MODIFICATION SHEET NO. RDSO/2024/EL/MS/0497, Rev. '0', Dated 09.02.2024

Modification Sheet for Power Supply to Real-Time Train Information System (RTIS) devices in Tap-changer based conventional Electric Locomotives & 3-Phase Electric Locomotives

Figure:1 Modified Power supply scheme for Tap-changer based Conventional Electric Locomotives

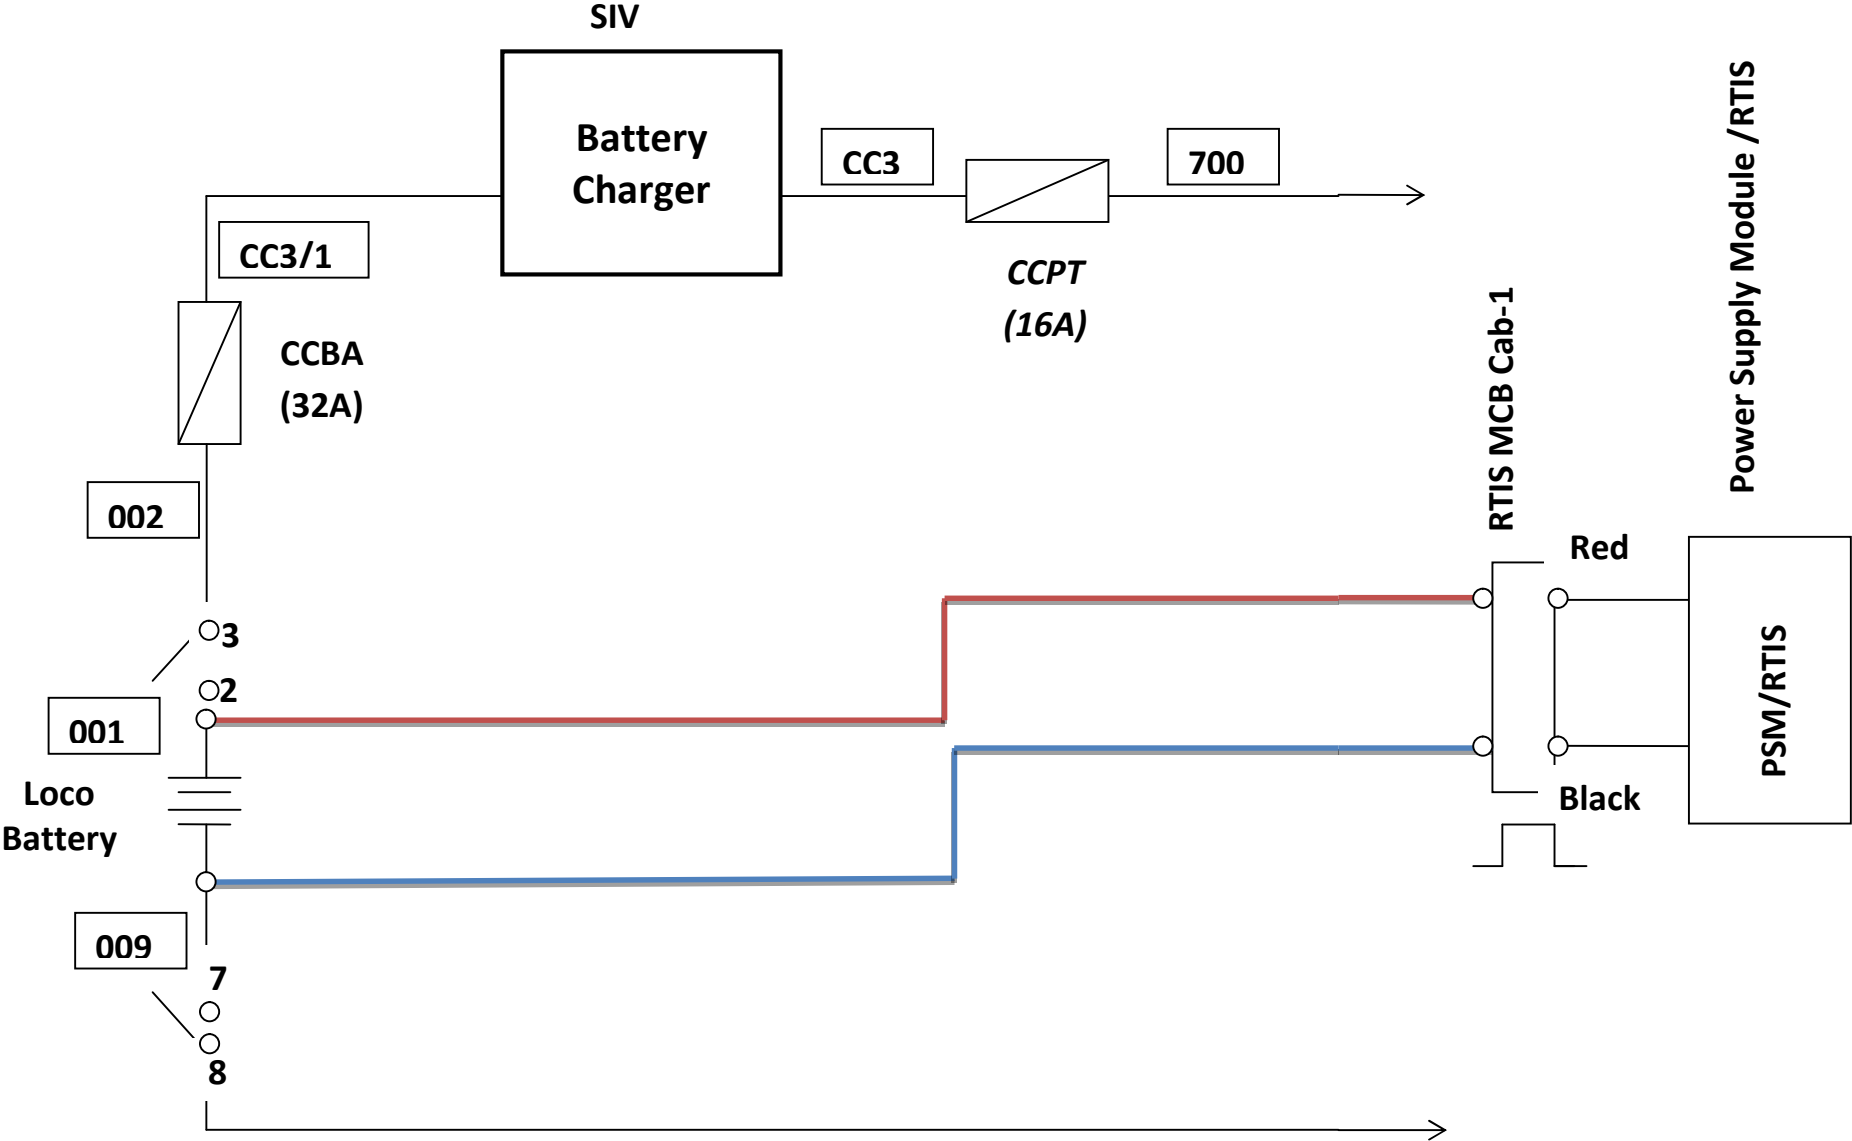
4.1 The power supply for RTIS is to be tapped before HBA (**wire no. 001 & 009**) in Tap-changer based conventional Electric Locomotives as shown in **Annexure-1**

Figure: 2 Modified Power supply scheme for 3-phase Electric Locomotives

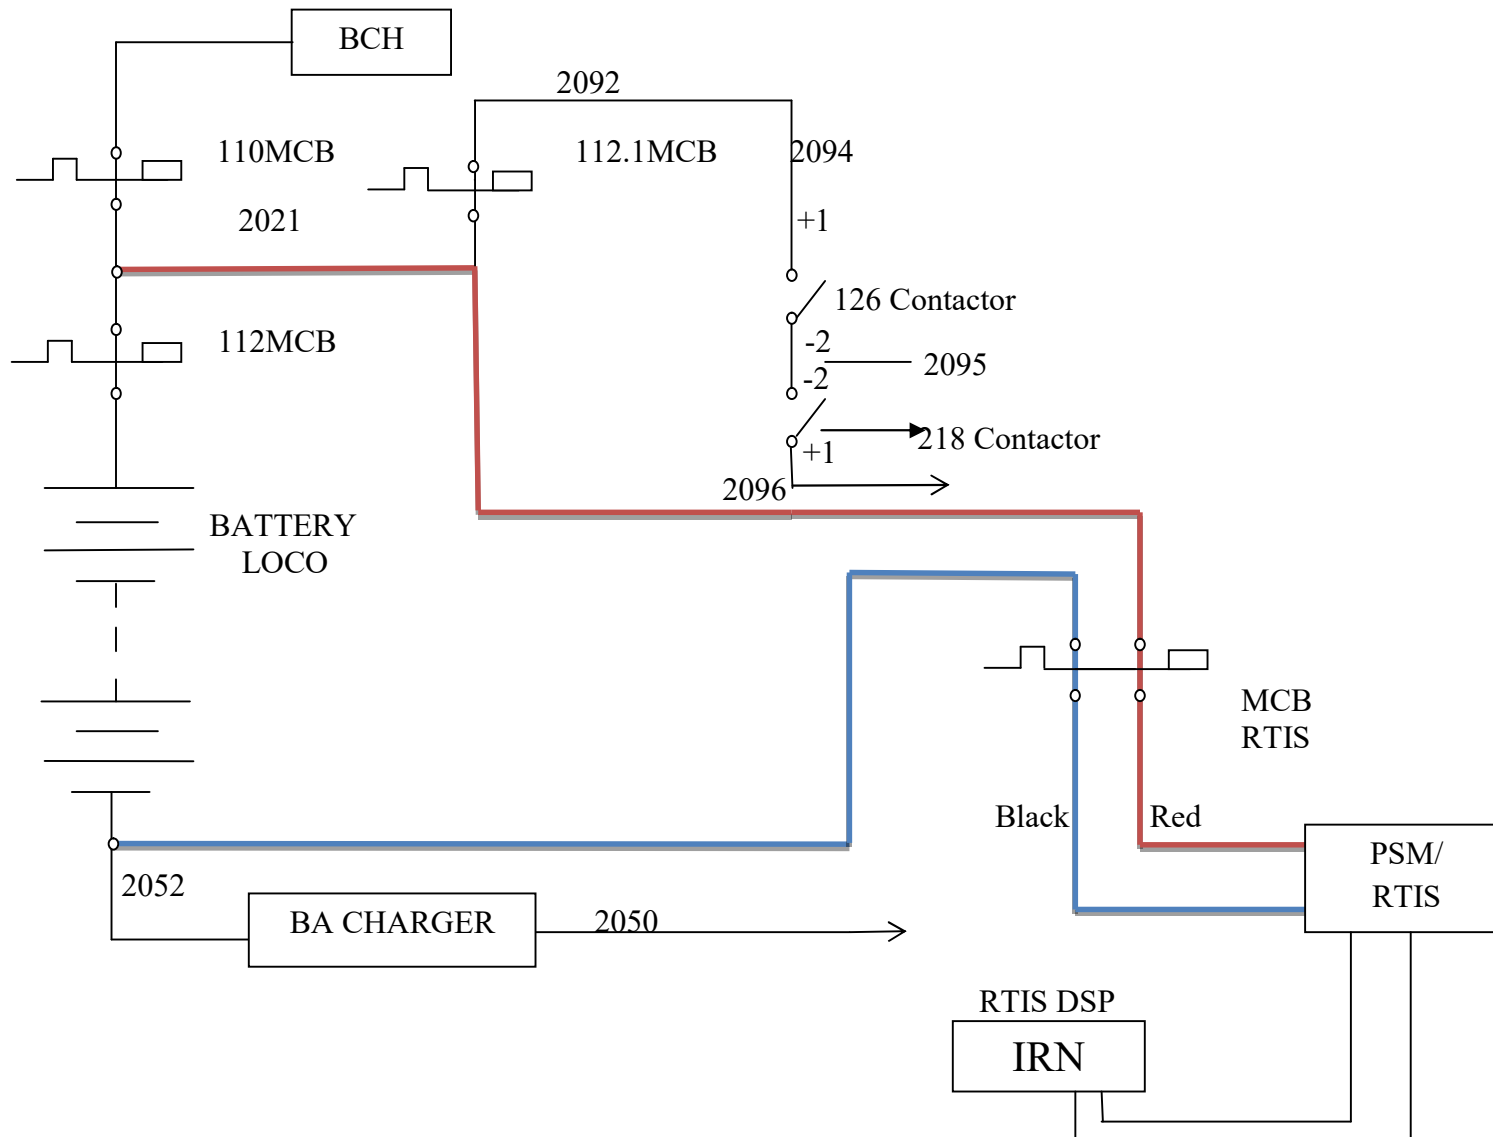
4.2 The power supply for RTIS is to be tapped before 112.1 MCB(**wire no. 2021 & 2052**) in 3-Phase Electric Locomotives as shown in **Annexure-2**.
